FOUNDATION INVESTIGATION REPORT

W.P. 95-90-01/96-90-01 Bridge Site 10-44

Hwy. 401 and Campbellville Road

Re: Campbellville Road Overpass
Hwy. #401, WP95/96-90-01

CAMPBELLVILLE ROAD OVERPASS
DOUBLE ROW 508mm Ø CAISSONS

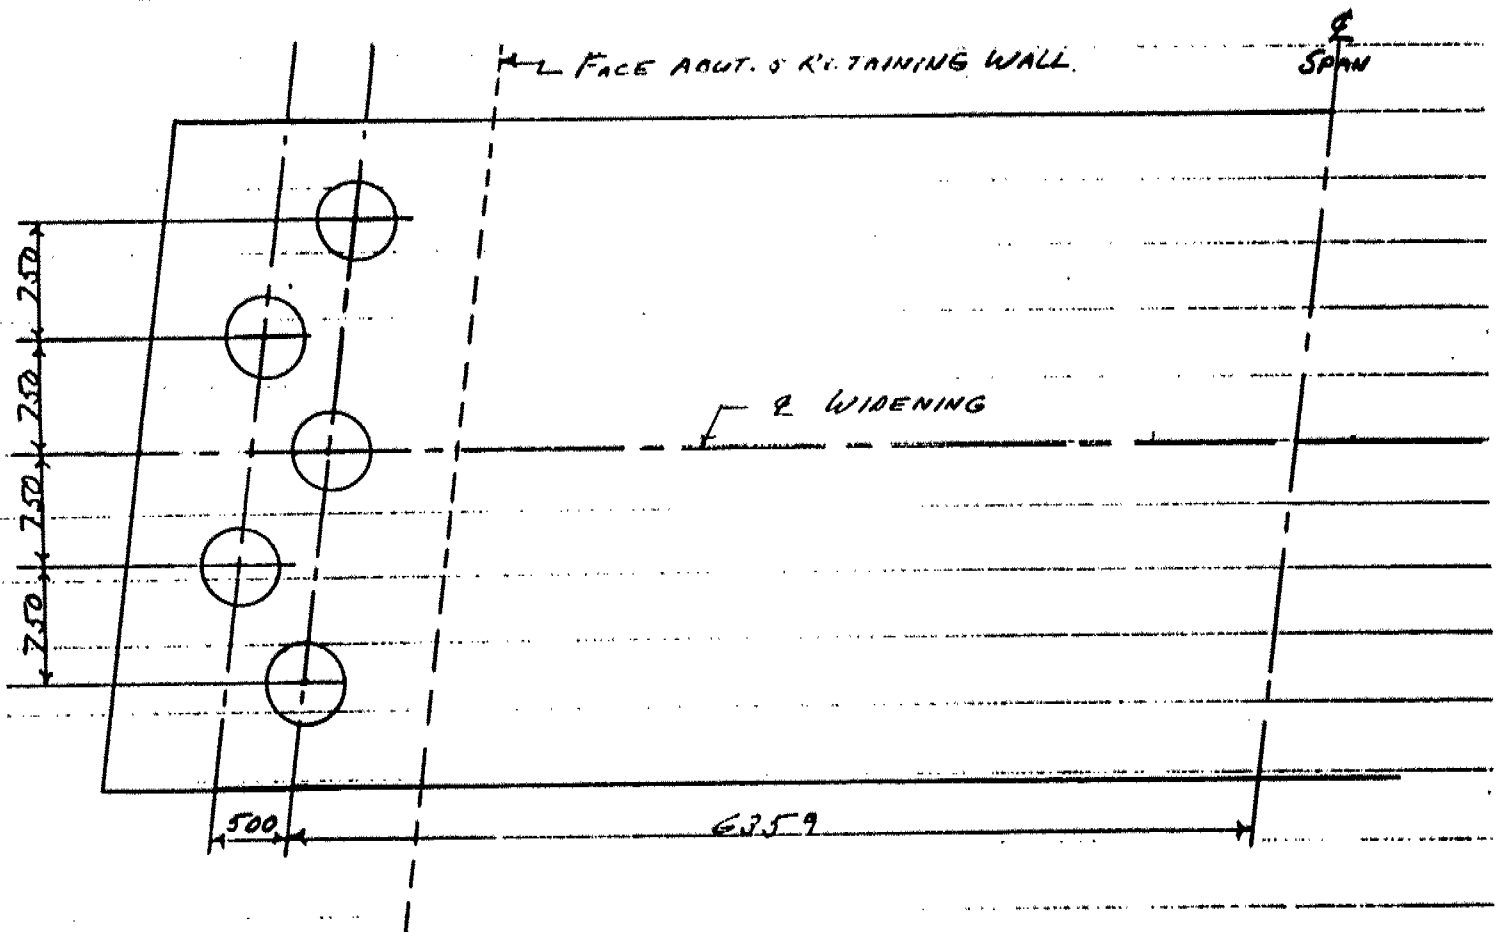
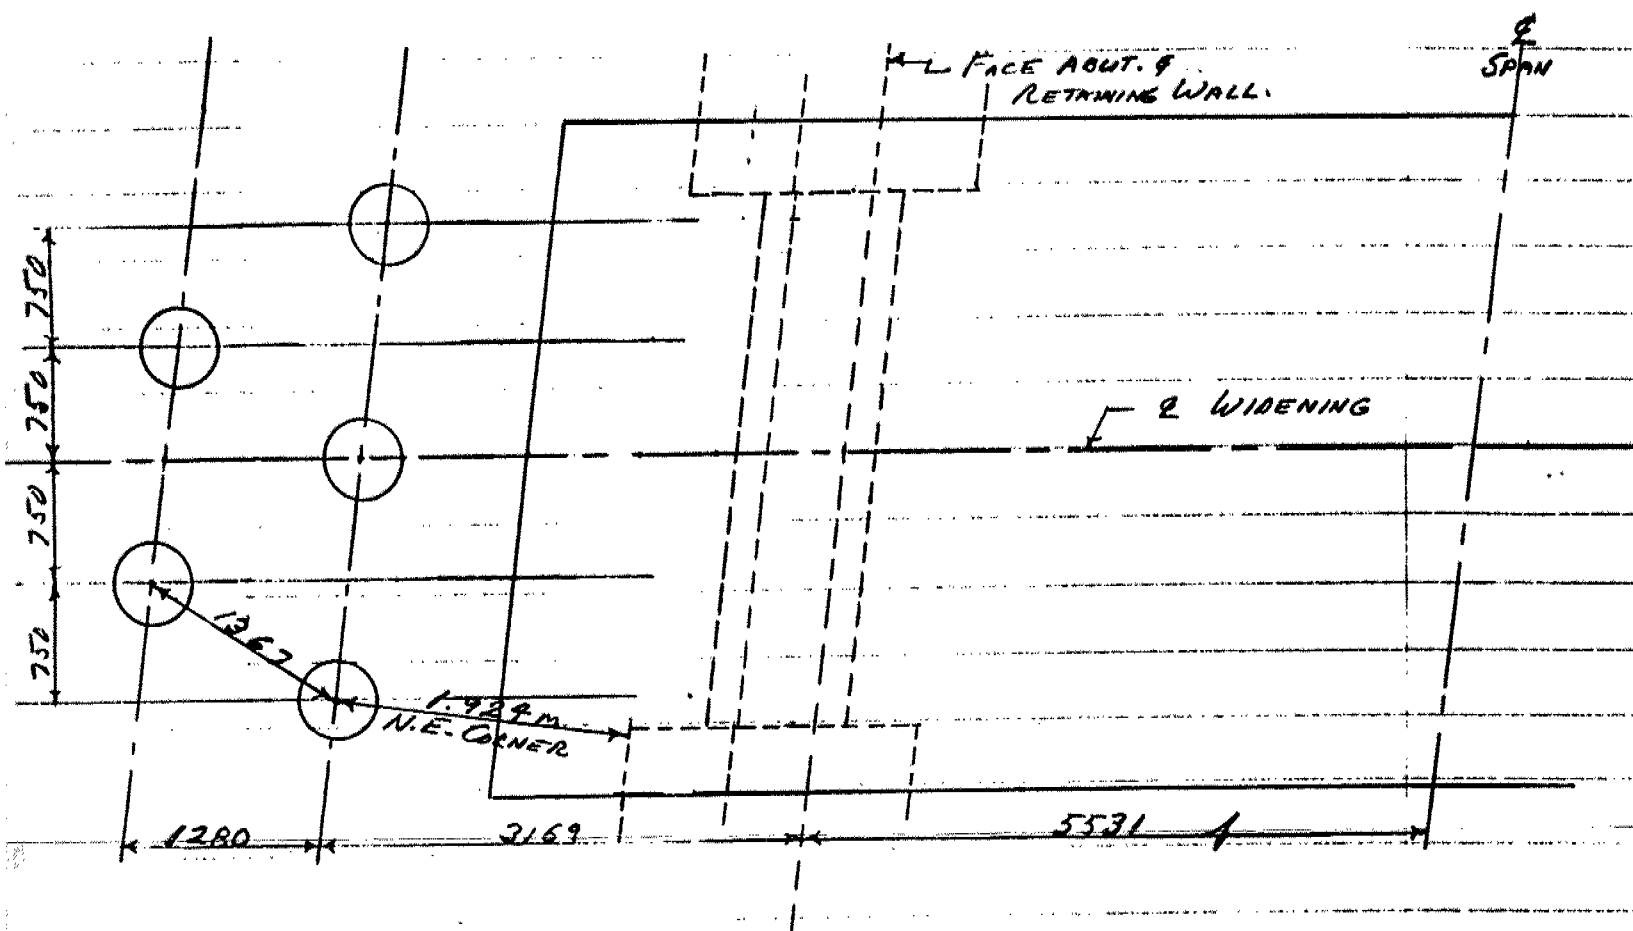
As discussed in our recent telephone conversation, we have revised our concrete filled end bearing support caisson layout to match the minimum clear distance of 1.5 times the dia. of the caisson as required by your M.T.O. Foundation Office. We understand that they will not accept the use of any piling as outlined in our proposal of June 14, 1991.

We are enclosing sketches showing three different views. The first is a plan view taken at the bottom of the deck haunch or the approximate top of the caisson. The second is a plan view at the bottom of the caisson which is also the bottom level of the existing footings. The third view is a longitudinal half section taken along the centreline of the new central structure.

We have attempted to try to find a support solution which results in the bottom of the caissons at a minimum clear distance of 1.5 times the dia. of the caisson. We have used two rows of caissons with a greater total number of support units, in order to lower the individual loading and the anticipated settlement.

We are proposing the use of five-508mm dia. concrete filled caissons with three in the front row and two in the rear row. If we were to install both rows of caissons at a 1 in 3 batter, this would mean that the top of the caissons would be approximately 1,280 mm between the rows as measured along the centreline of the widening. This adds greatly to the span of the structure, and presents design problems with the distribution of the negative moment from the caissons and the distribution of the loading equally between the front and the rear row caissons.

To solve our design concerns at the top of the caisson, we have altered the batter on the front row to 1 in 4, while maintaining the batter on the rear row at 1 in 3. This results in the distance between the front and rear rows of caissons at the top being reduced to 500 mm while providing the distance between the bottom of the caisson rows at 1,280 mm.

This layout matches foundations individual spacing of the caissons at the bottom of caisson level where in the front row the distance between caissons is 1,512 mm centres, or 1.98 times the dia. clearance. The closest distance of the caissons in the second row to the caisson in the first row is 1,367 mm centres or a minimum clear distance of 1.69 times the dia.

The use of the front row of caissons at the 1 in 4 batter does result in the closest outside caisson distance being slightly reduced to 1.924 m from the centreline of the caisson to the corner of the existing footing projection at the northeast corner of the new structure which is the closest point. With the original 1 in 3 batter, this distance was 2.689 m.

With the slight increase in loadings using the increased half span length of 6,609 mm to the mid-point between the first and second row of caissons, we have a total dead load and live load force of ULS 1,586 kN and SLS 1,154 kN. Distributing the SLS load evenly among the 5 caissons would result in a load per caisson of 231 kN. From the soil investigation report we anticipate that this would be an estimated settlement of 14 to 19 mm. If this is correct, we would propose that we dowel the new central bridge structure to the sides of the existing structures.
